Technical Service Information

THM 3T40 (125C) NEW AUX VALVEBODY GASKETS FOR 1988 - UP

Figure 1

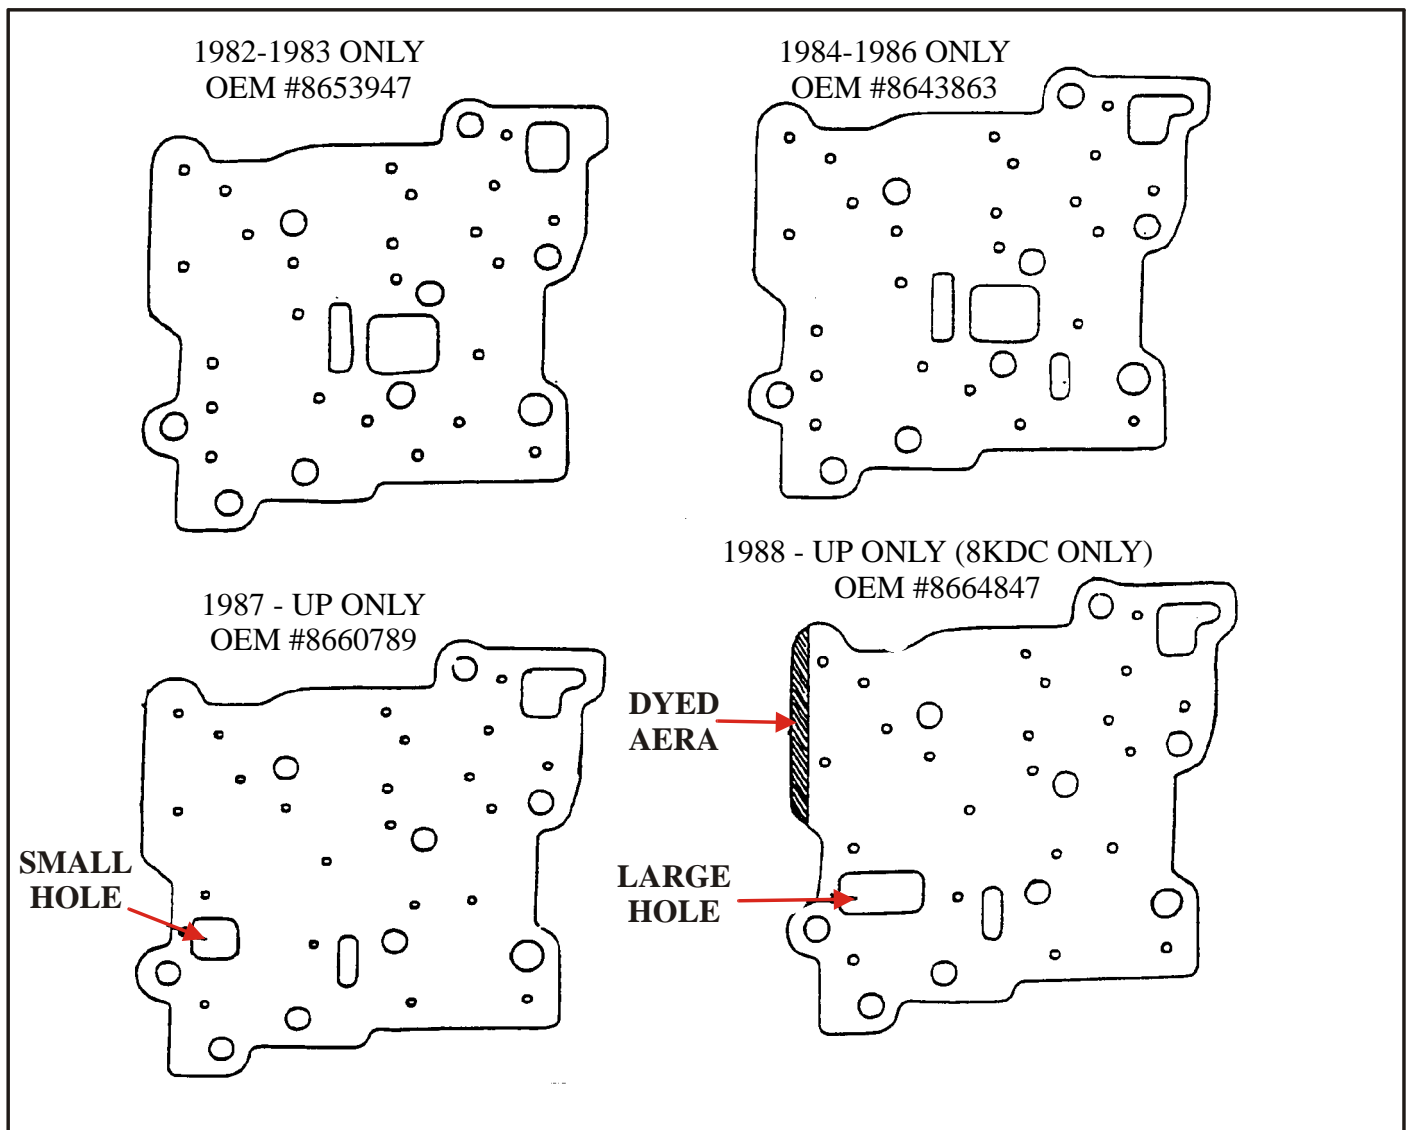
For 1988, approximately 15% of the THM 125C transaxles require a new auxiliary valve body cover gasket. The new gasket is being used in "N" body cars (Calais, Somerset, and Grand AM) ONLY at this time.

The new gasket has a larger hole than the 1987 gasket, and a dyed area on the gasket for identification (See Figure 1).

This now makes four (4) auxiliary valve body cover gaskets for the THM 125C, and they "CANNOT" be interchanged with each other (Figure 1).
